**MONTGOMERY COLLEGE - OFFICE OF PROCUREMENT
UNDERGROUND CHILLED AND HEATING WATER PIPING REPLACEMENT – PHASE 1
ROCKVILLE CAMPUS
RFP NO.: E621-006
RFP CLOSING DATE AND TIME: APRIL 9, 2021 @ 2:00 PM**

**ADDENDUM #1
Issued: March 31, 2021**

**BKM PROJECT NO. 19104.01
 ADDENDUM 1
 APRIL 1, 2021**

M2.02

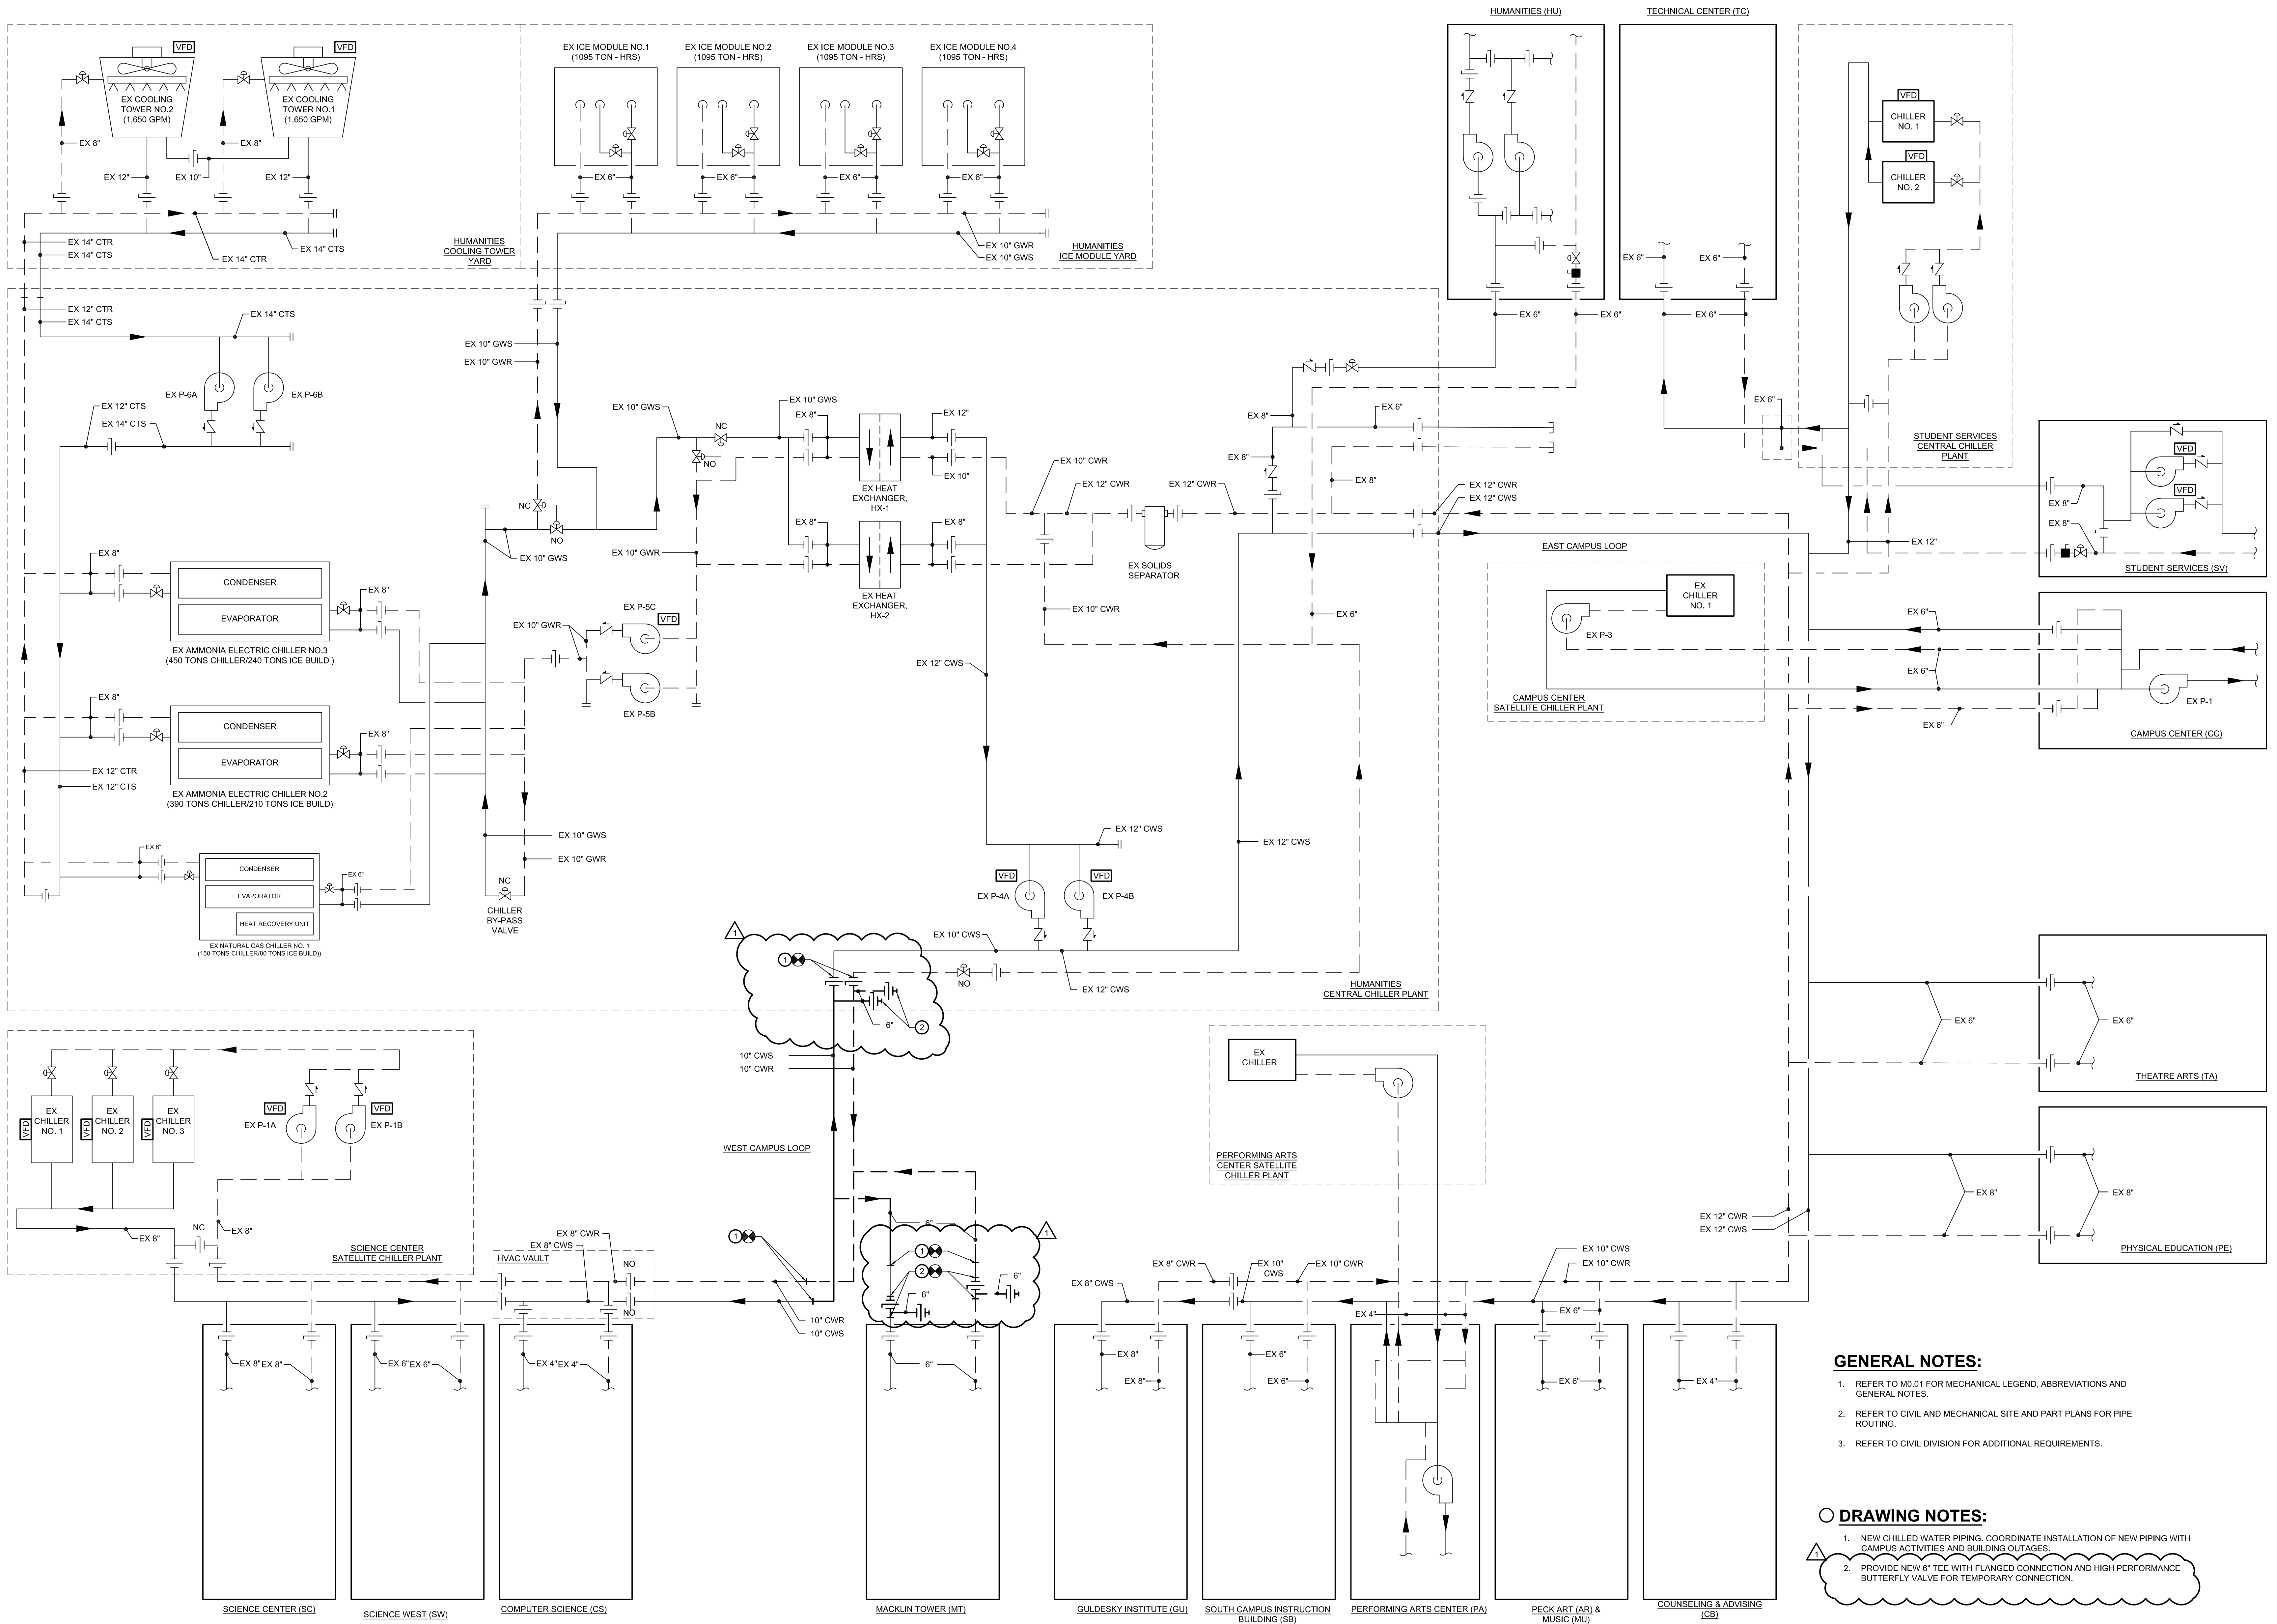
M2.02: New drawing sheet, addition of 6” flanged connections for temporary piping connections

- PROVIDE NEW 6" FLANGED CONNECTION WITH NEW SHUTOFF VALVES ON CHILLED WATER SUPPLY & RETURN PIPING FOR TEMPORARY CHILLED WATER PIPING CONNECTION. EXTEND TEMPORARY PIPING FROM FLANGED CONNECTION TO HUMANITIES FOR EXTENT OF CHILLED WATER OUTAGE TO MACKLIN TOWER. REMOVE AND CAP FLANGE AT COMPLETION OF CHILLED WATER OUTAGE.
- TEMPORARILY ROUTE 6" 150 PSIG CHILLED WATER FLEXIBLE PIPING THROUGH AREAWAY TO HUMANITIES. COORDINATE ROUTING WITH ALL CONSTRUCTION ACTIVITIES AND PROVIDE PROTECTIVE MEASURES TO PREVENT DAMAGE TO PIPING FOR EXTENT OF USAGE.
- EXISTING UNDERGROUND HEATING AND CHILLED WATER PIPING. REFER TO SITE PLAN FOR CONTINUATION.
- EXISTING HEATING AND CHILLED WATER PIPING TO/FROM MACKLIN TOWER.
